CAMPAIGN BULLETIN

Anti-lock Braking System (ABS) Actuator Voluntary Safety Recall Campaign

Reference: R1916 and R1920 Date: September 30, 2020

UPDATE September 30, 2020 Please discard earlier versions of this bulletin.

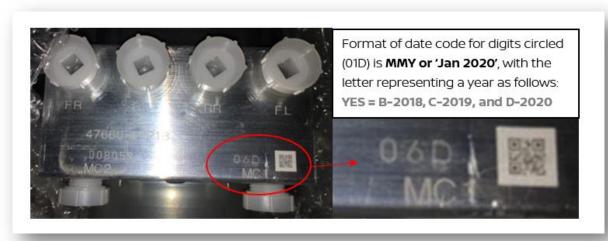
Q. How do I identify if unused parts in inventory have exceeded their shelf life?

A. The date code should be located on the part as per the screenshot below:

Alternatively, if the date code is damaged or illegible, a QR Code Reader application may be downloaded to a smartphone and used to scan the QR code to identify the manufacture date of the part.

A limited quantity of parts may contain the following date format:
